**ALERT SERVICE BULLETIN**

NO. 430-09-43

**MODEL AFFECTED:** 430

**SUBJECT:** REVISED OPERATING LIMITS, INTRODUCTION OF

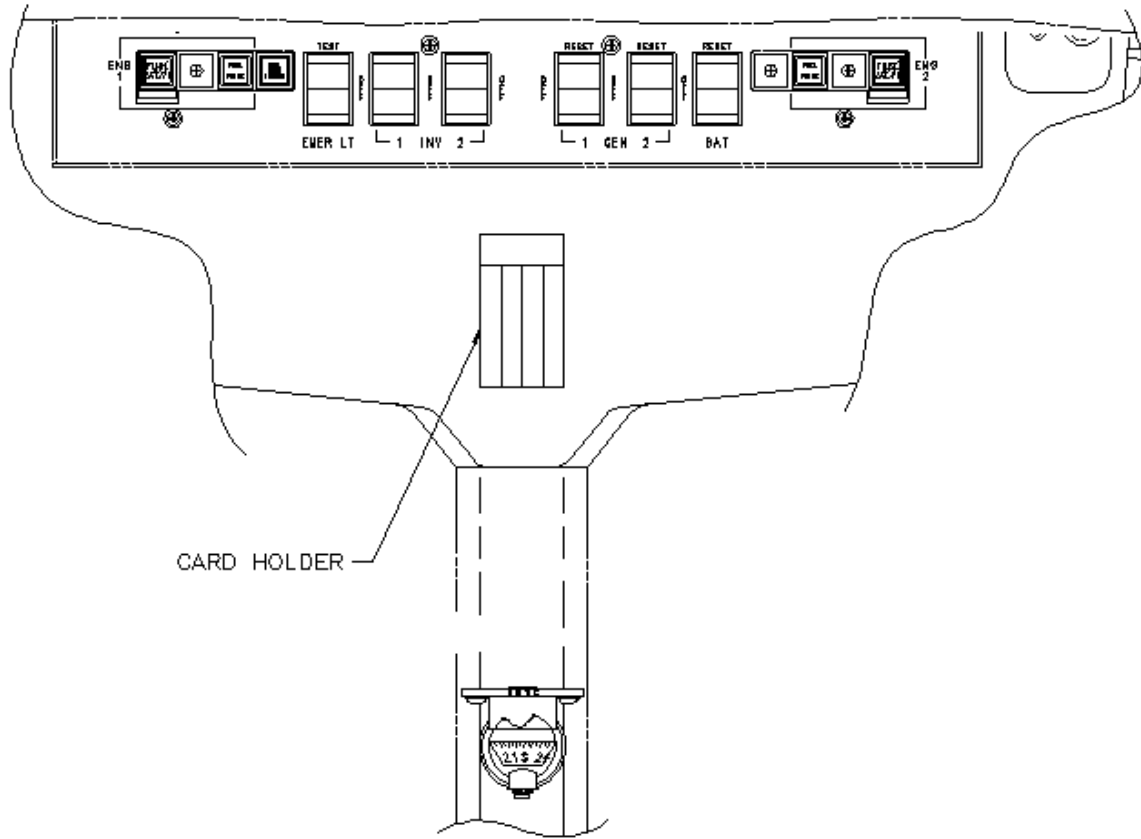
1. Carefully remove compass correction card holder from existing location on the overhead headliner panel. Retain all parts. Refer to Figure 1.

2. Install previously removed compass correction card holder on the lower portion of the headliner panel. Refer to Figure 2 for new location details. Bond card holder to panel with adhesive (C-301)
